*Revised* AGENDA

LANDMARKS PRESERVATION  
ADVISORY BOARD  
OAKLAND, CA 94612

December 8, 2014

**RE: The Bureau of Planning's preliminary design comments on Children's Hospital and Research Center Oakland (CHRCO) Master Plan Application**

Outpatient Center 2 (OPC2)

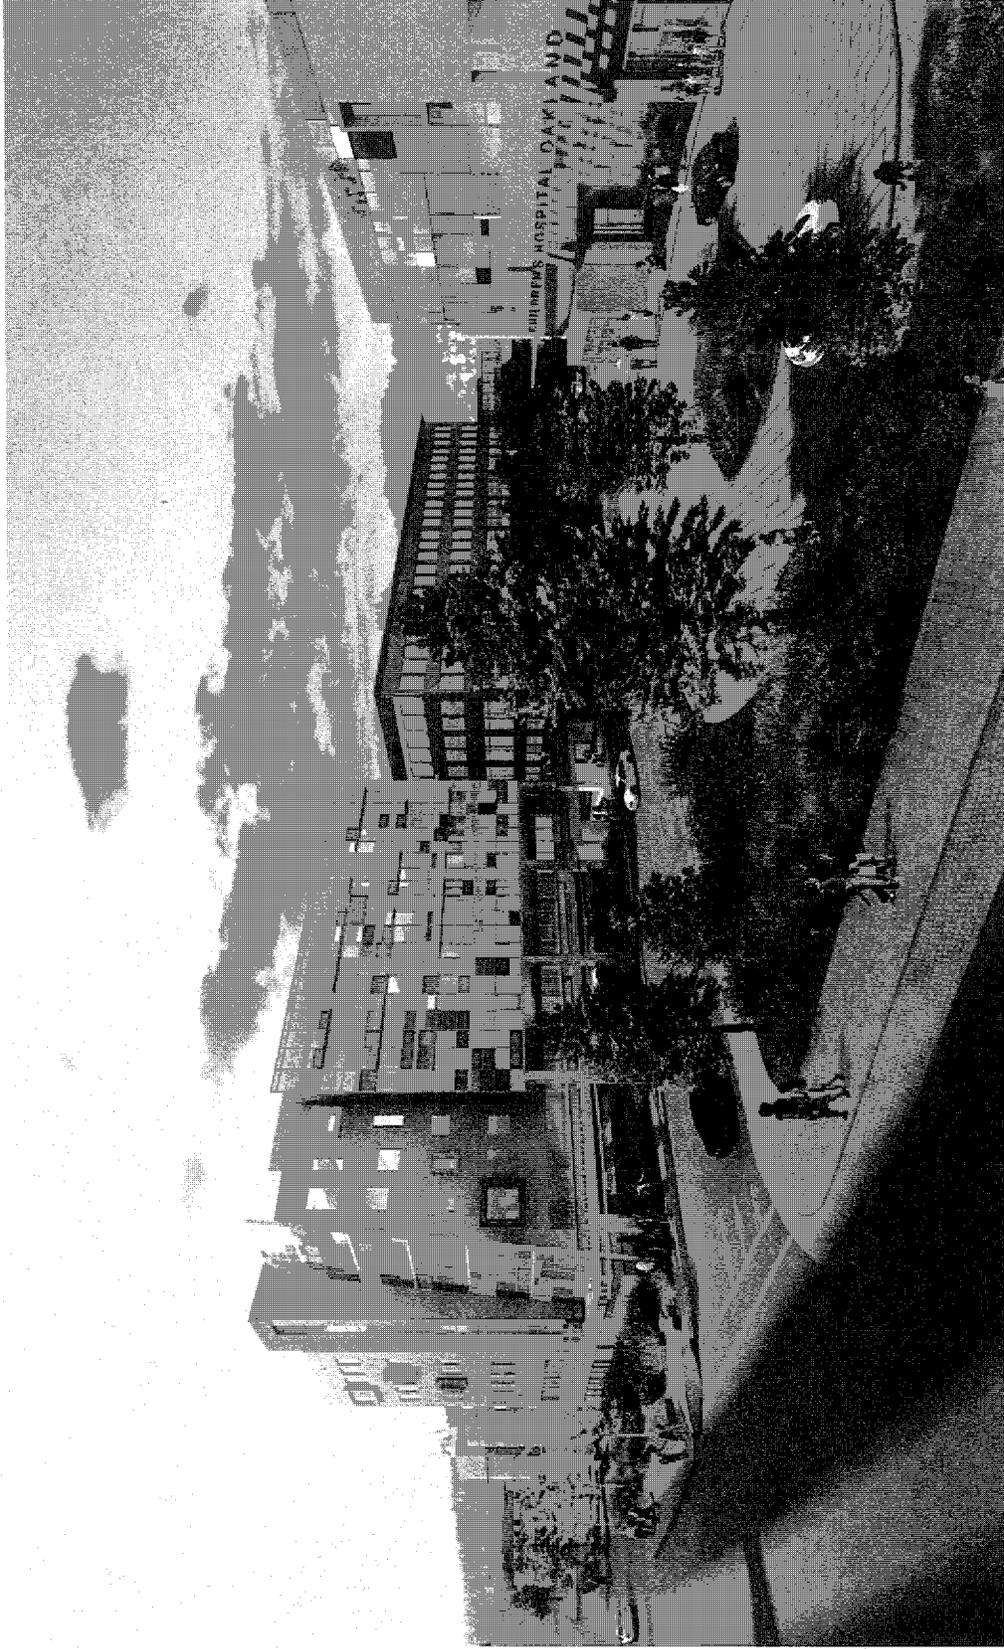
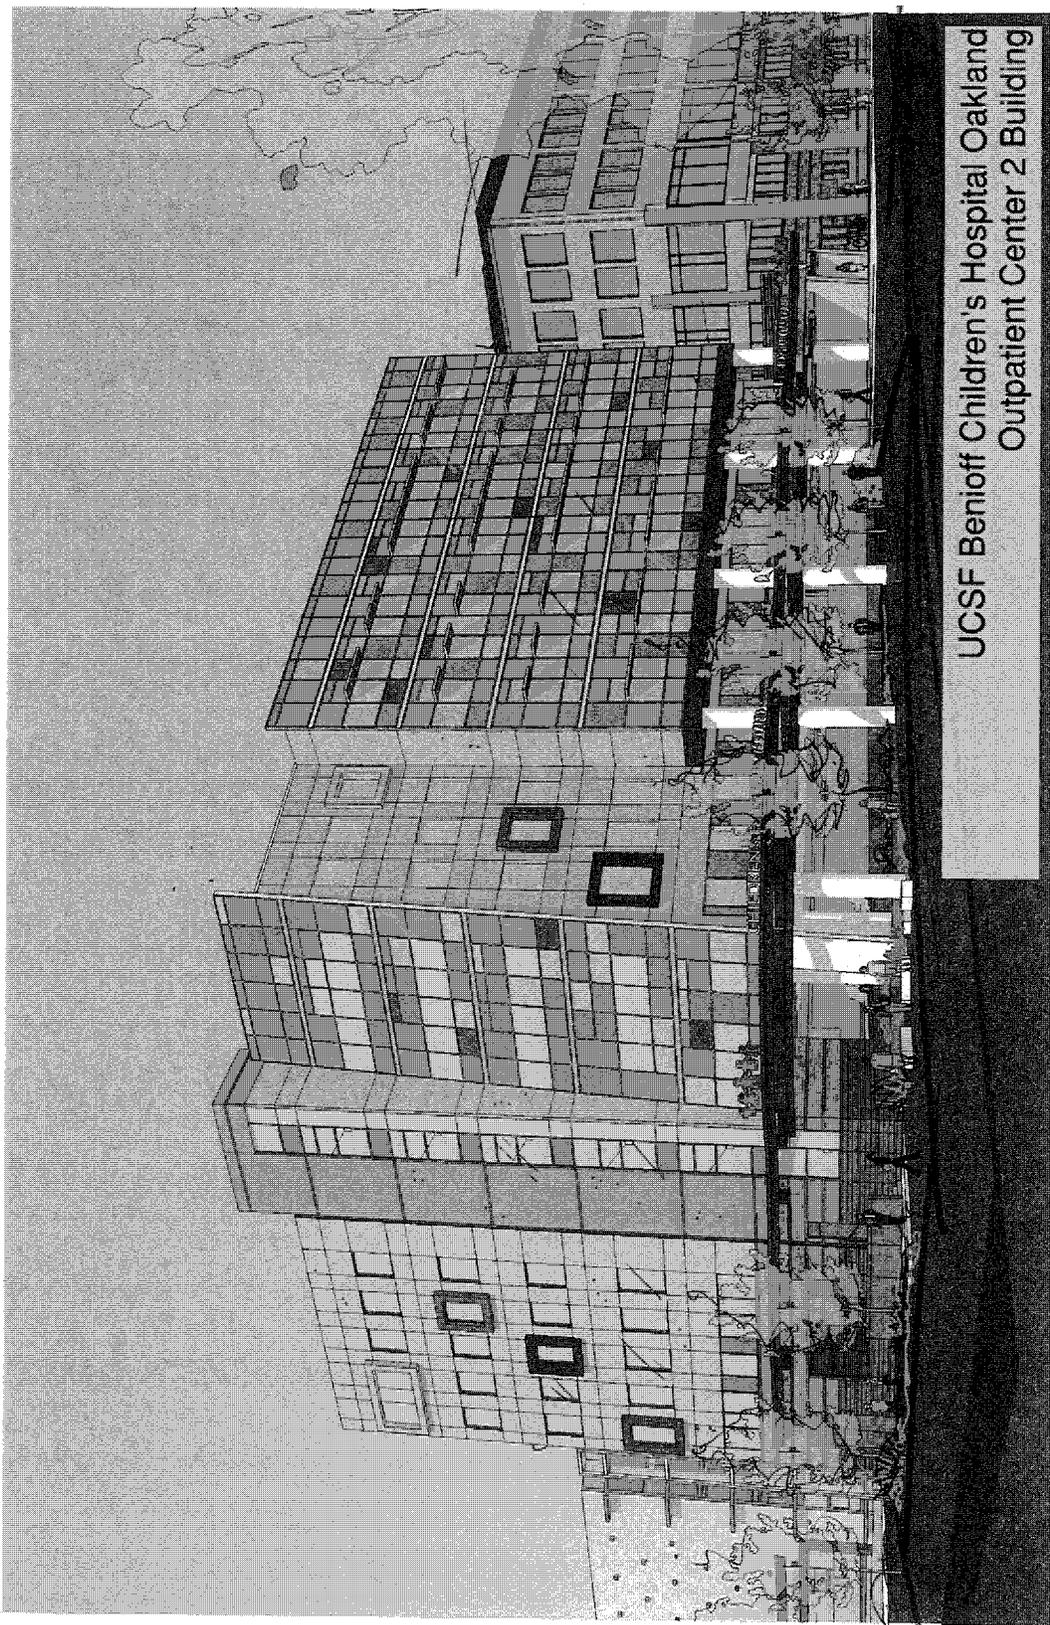
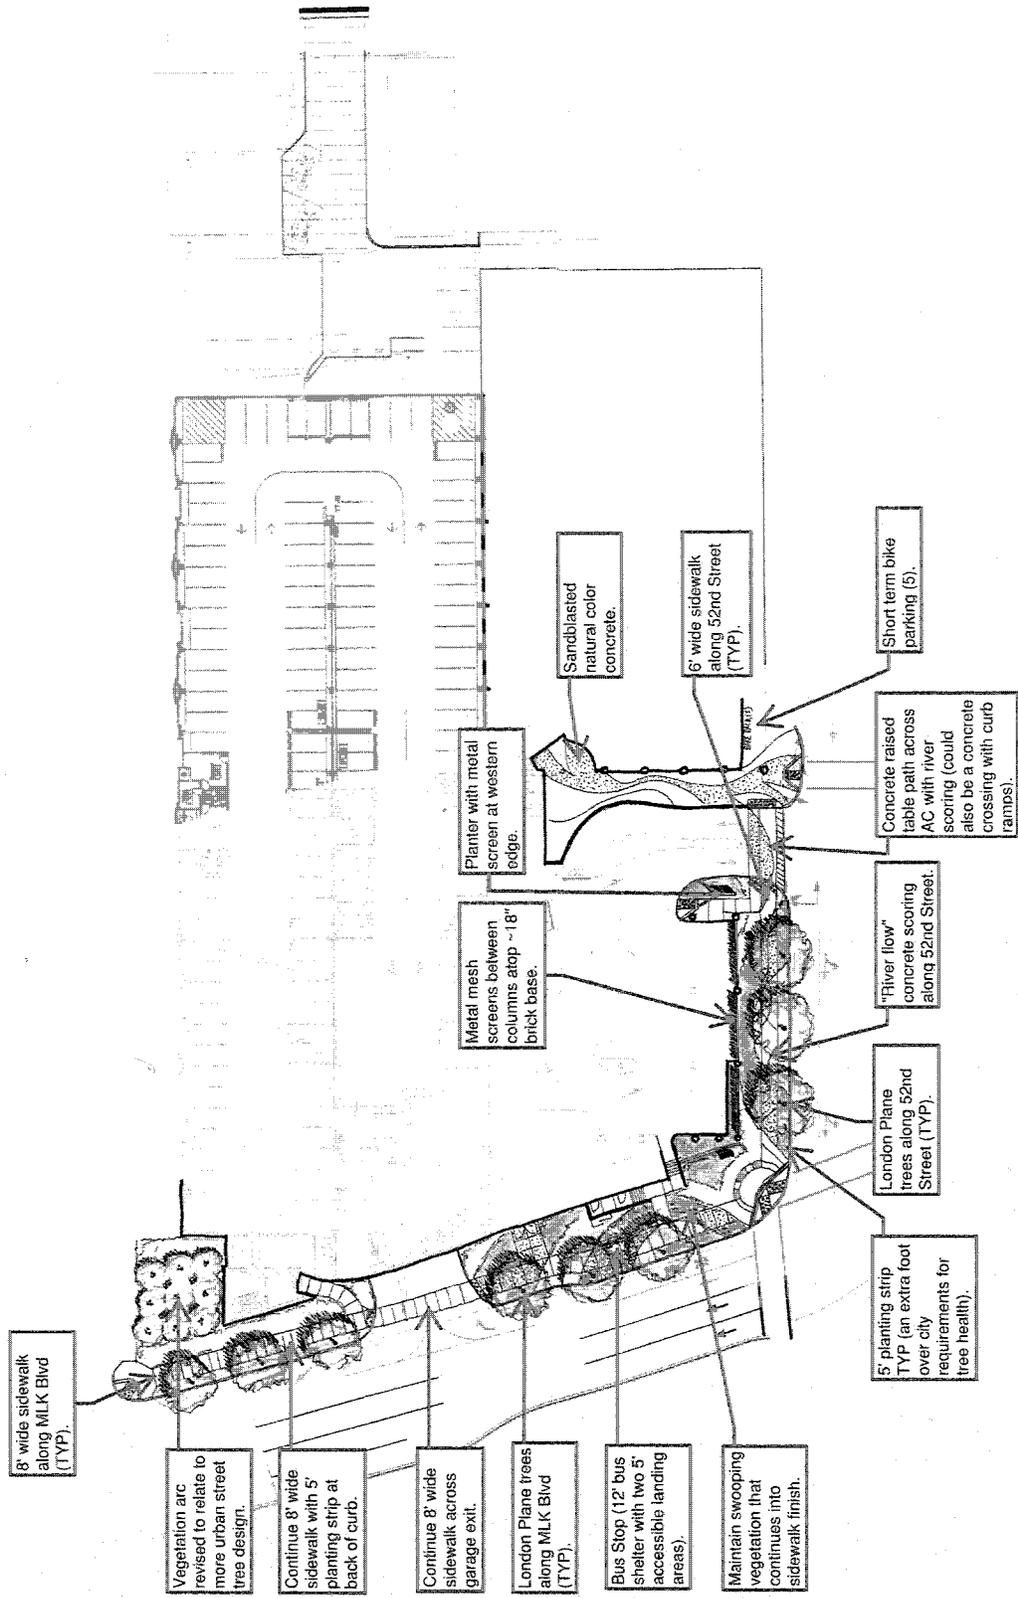
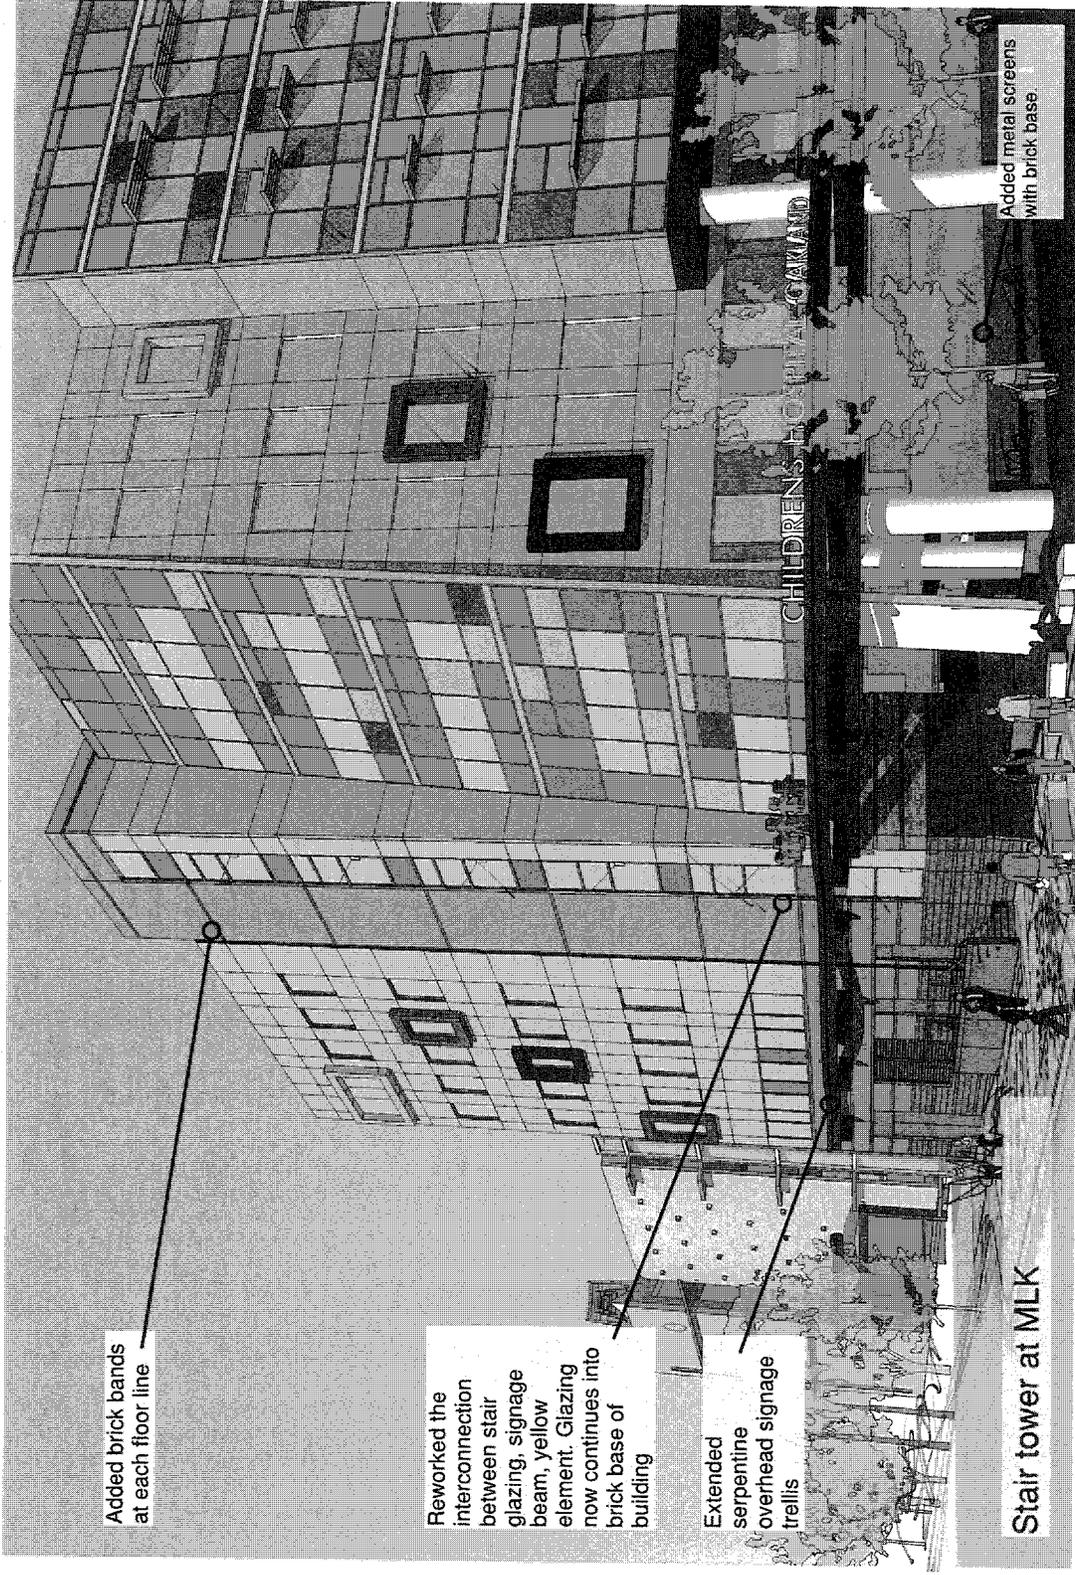
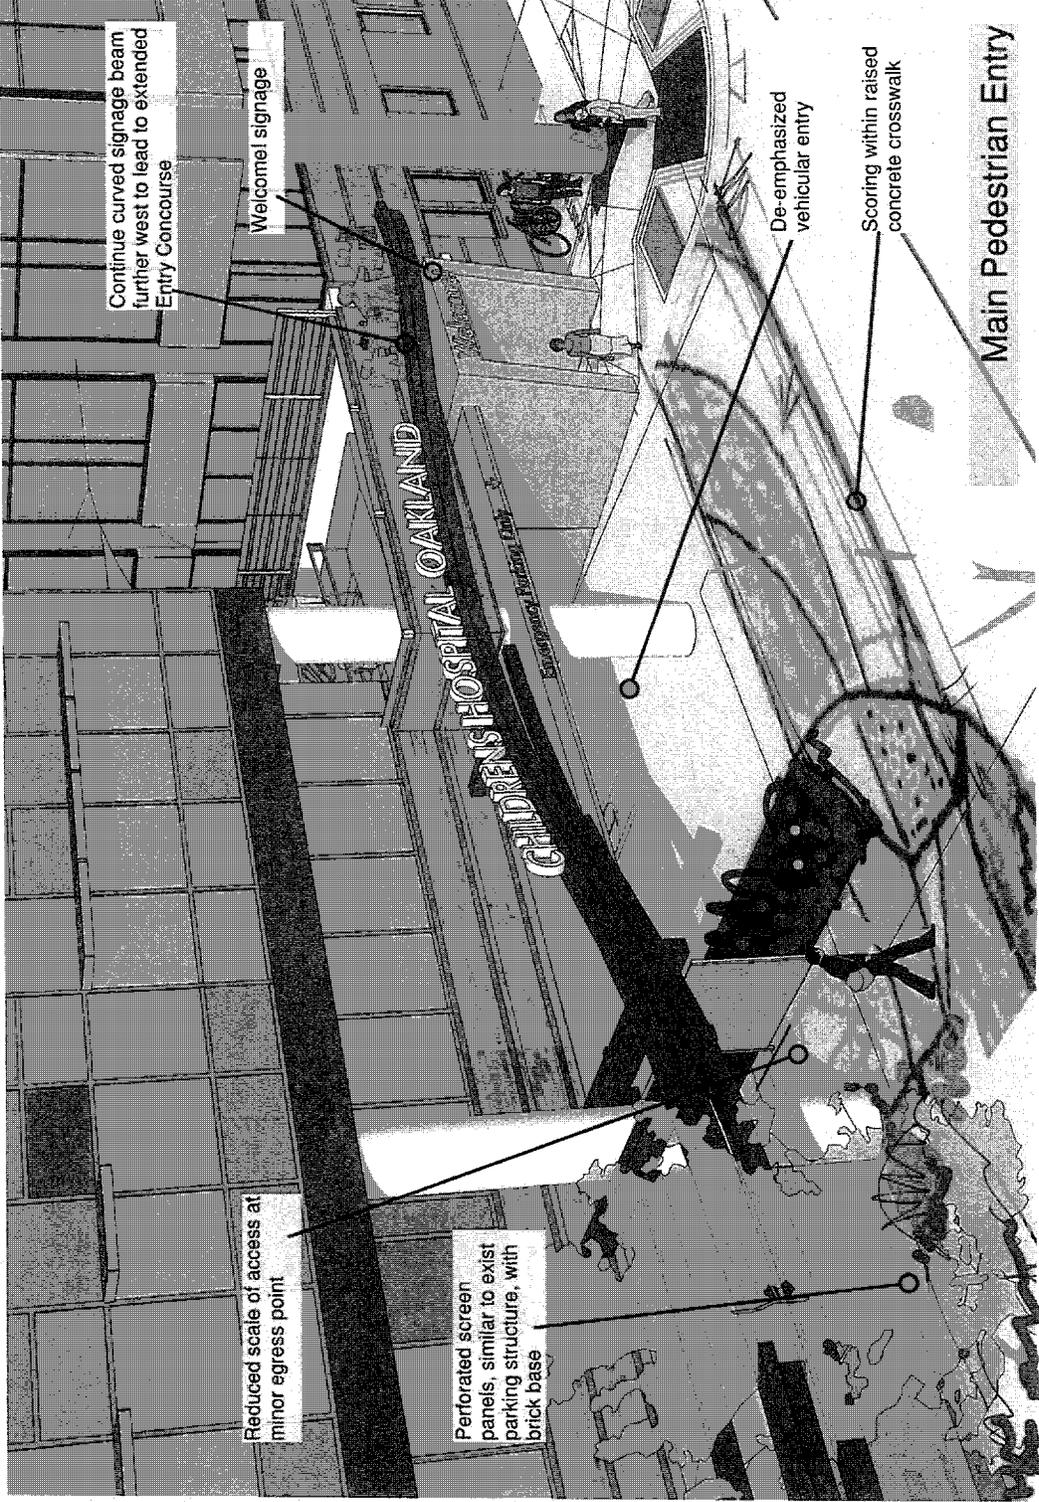
5. In our May 13, 2014 letter, Planning staff noted that "There needs to be a new visually interesting main entrance to the OPC buildings. It is not ideal that patients would park on the ground floor, as that is reserved for emergency uses, and then take the elevator up to the 2nd Floor." The revised plans have not been revised to reflect this comment. To be more specific: All buildings should have a clearly defined pedestrian entrance and this building does not. The building is oriented inward and is designed around the automobile and parking garage instead of the pedestrian. The facades of the building should orient you to the entrance. Currently, all elements of the design, including the tilted glass curtain wall and the large signage on the steel canopy, point to the corner as the entrance. The eye is drawn actually not to the glass curtain walls but to the stucco area between. There should be some flow around the corner to invite pedestrian down the street and pedestrians to the hospital campus entrance. The recess element adjacent to OPC1 further deemphasizes and hides the entrance to the building.

- a) The building needs a clear and identifiable pedestrian entrance. This requirement can be accomplished in many architectural ways such as the addition of a screen, atrium, parapet, or some vertical element adjacent to the OPC1 which will fill the recess, denote the entrance as a focal point and provide a unifying element to tie OPC1 and OPC2 together.

- i. In lieu of a vertical element, another option would be to provide a canopy or some other prominent, entrance-defining element that is integrated into the building design, extends out to the street, and is visible enough to allow for signage which directs pedestrians to the building.

- ii. Any entrance element needs to be more prominent than the parking garage entrance. In order to accomplish this, the entrance element should extend into the garage and align with the elevator waiting area and the crosswalk to the Hospital's Emergency Department to create a direct path of travel for the pedestrian. In addition, the garage entrance should be moved toward MLK to provide as much of an entrance area as possible. This might require reducing the travel lanes into the garage, possible loss of an emergency vehicle parking space and relocation of the traffic signal. The proposed second pedestrian entrance into the garage flanking the driveway should be removed to accommodate relocation of the parking garage entrance toward MLK. In addition, the actual entrance to the building in OPC1 should be closer to the street which might require interior alterations on the ground floor of OPC1. There should be a wall or other architectural separation between the garage and the pedestrian entrance, not just bollards or a curb.

- b) Currently the building has multiple planes that don't seem to relate to each other in material, pattern or scale. The glass curtain walls should be used as the element that break

up the overall building mass. These features should be integrated into the design not just adhered to the side of the building. This is especially important detail when the planes of the building are viewed from the side. Further consideration should be given to the building plane corners and how different materials intersect.

- c) The yellow stucco plane on the stair tower should be changed to brick. The brick façade should be used equally with the colored glass panels as identifying architectural elements for the Master Plan. The stucco portions should recede in the design hierarchy.

- d) Instead of the boxes around the windows, recessed colored glass panels should be considered. This would tie the glass curtain walls to the stucco building planes.

- e) If the emergency parking garage design does not include a wall or other architectural separation between the garage and the pedestrian entrance as noted above, the garage's ceiling should be finished out to provide a more a port-cochre style design than a typical parking lot. All lighting should be pointed downward and either conical or recessed with no blub exposure. Light should be a warm not a cool light.

- h) The stucco exterior stairwell along MLK should have metal railings so that people can see into the stairwell area from the street.
6. In our May 13, 2014 letter, Planning staff noted that "There should be some active ground floor uses in the OPC2 building." This comment was echoed by a commenter on the Draft EIR. Although Staff understands that ground floor commercial cannot be accommodated within the emergency department parking area, this doesn't mean that the pedestrian environment should be unpleasant. The applicant should revise the plans to reflect the comments in this letter regarding the pedestrian experience.
